ENGINEERING CHANGE NOTICE

PRODUCT CHANGE NOTIFICATION

Date Issued: September 3, 2014 Product Identification: All Bel 1xN ICMs(except 10G products). PCN Number: PC2140065

1). Take the detail change of 0899-1X1 tray packing for example:

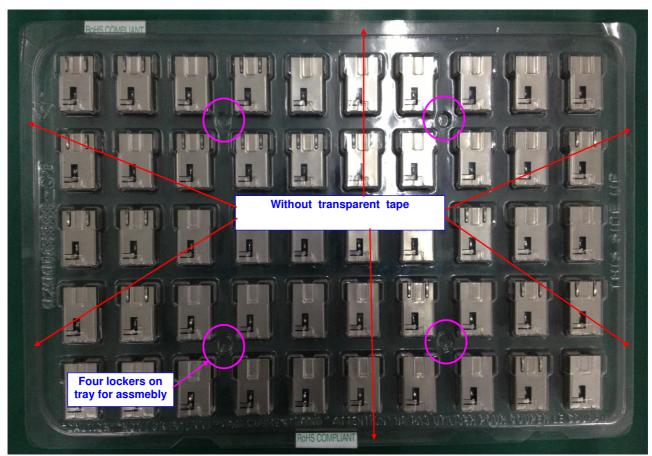
Detail change to remove the transparent tape in the tray packing process:

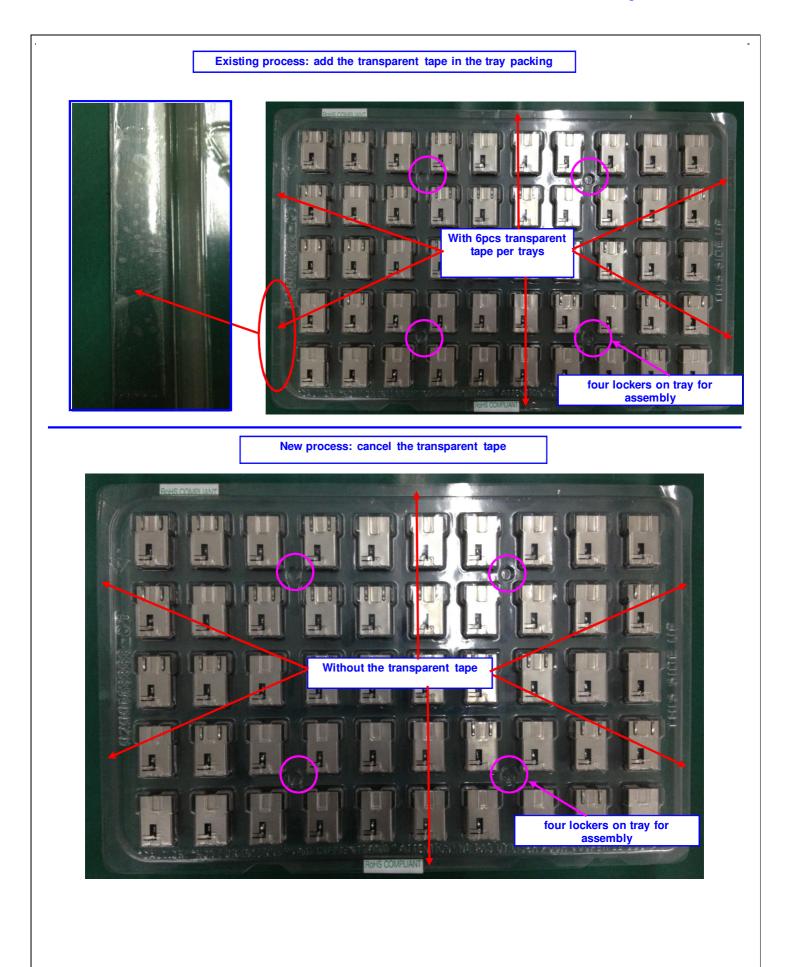
Description of the Change (s): Bel is updating the packaging of our 1xN ICMs as shown below. We are removing the small pieces of transparent tape from the internal trays within a box. The plastic tray locking features are sufficient to hold the product in place and prevent damage.
